OFFICE OF THE
TOWN PLANNER

McManus Subdivision – Master Plan
Staff Report for the October 26, 2022 Planning Board Meeting

Project Name:	McManus Subdivision	TRC Meetings: 10/18/2022
Application Type:	Major Subdivision	11/08/2022
Review Phase:	Master Plan	
Project Address:	552 River Road	
Plat and Lot:	AP 21 Lot 70	
Zone:	RS-12	
Land Area:	2.6 acres	
Future Land Use:	Residential Medium (1/4 - 1 acre)	
Owner/Applicant:	Daniel & Deborah McManus

Site Layout Plan (Sheet 2 of 3)

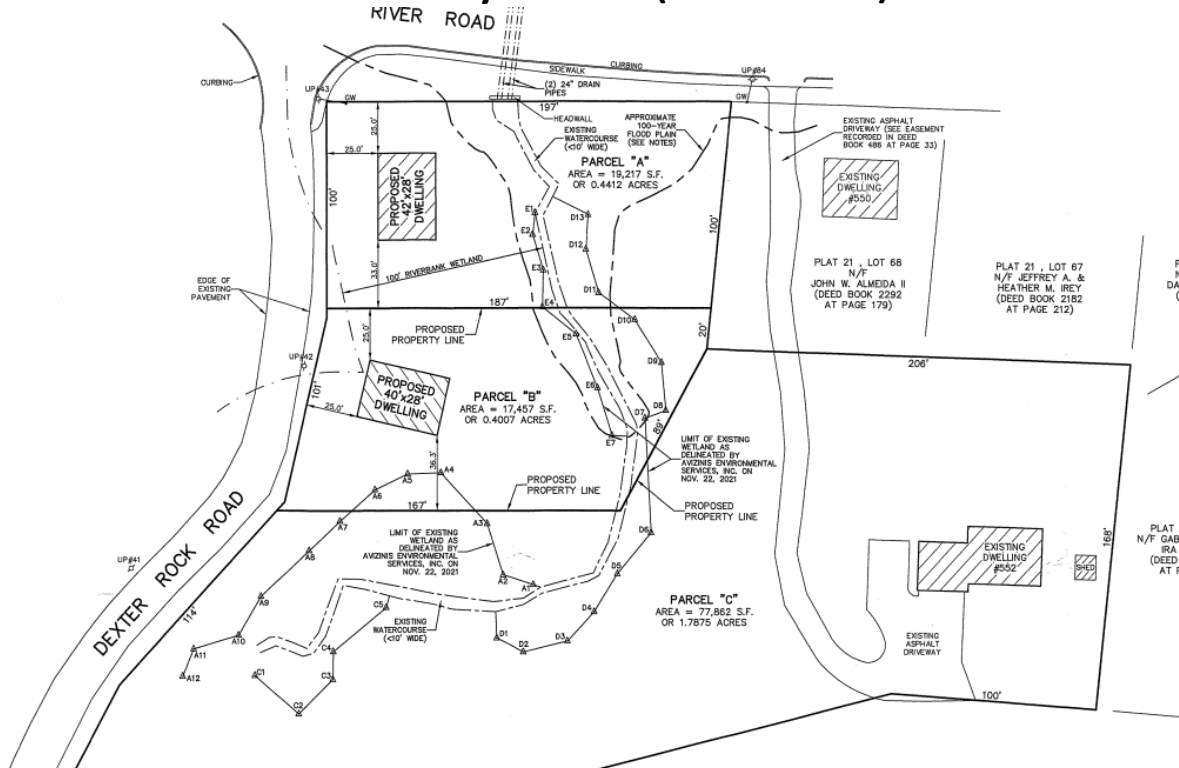
The parcel is located in the RS-12 (Residential Single Family on 12,000 ft² lots). All of the proposed lots meet/exceed the RS-12 zoning requirements. During the TRC meeting, because the building foundation is shown to abut the building setbacks, Mr. Ward asked that the applicant stake the foundation for the residence on proposed Parcel A. Mr. Ward also asked for a clarifying note on the side corner setbacks for proposed Parcel A. The revised plans dated 10/24/22 provides the note.

1. Provide an NBC permit as part of the Preliminary Plan submittal.
2. Provide a RIDEM wetlands permit for this application as part of the Preliminary Plan submittal.
3. Provide sight distance calculations for proposed driveways at Preliminary Plan.
4. Add setback lines to the Site Plan (sheet 2 of 3).

Development Plan (Sheet 3 of 3)

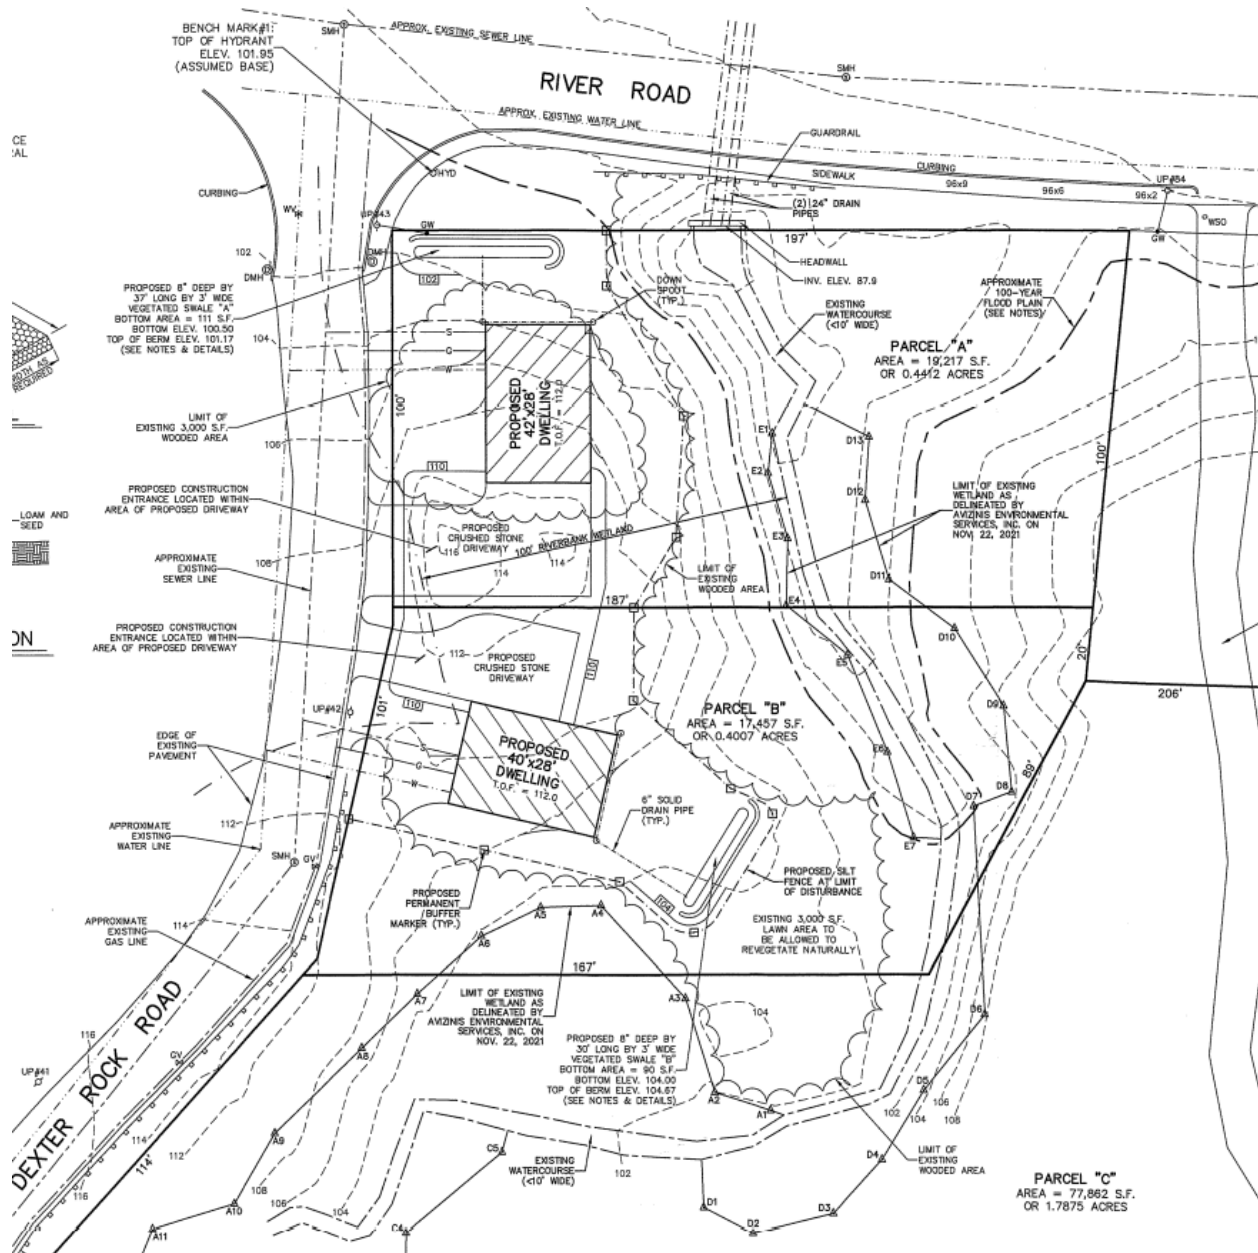
The subject lot is 2.6-acres and contains one structure to remain on proposed Parcel C. Proposed Parcels A and B will be carved out of the northern corner of the site, between the wetlands and Dexter Rd and River Rd. Although there is sufficient land area for further subdivision, it is the wetlands that prevent further subdivision. The new developable lots, Parcels A & B, will have frontage and driveways on Dexter Rock Road. Both driveways are located next to the abutting interior side lot lines and are proposed as crushed stone.

There are existing trees in or near the right-of-way of Dexter Rock Road. Mr. Gagnon wanted the applicant to know that it will be the developer's responsibility to remove the trees as applicable, that is would not be the responsibility of the Town.
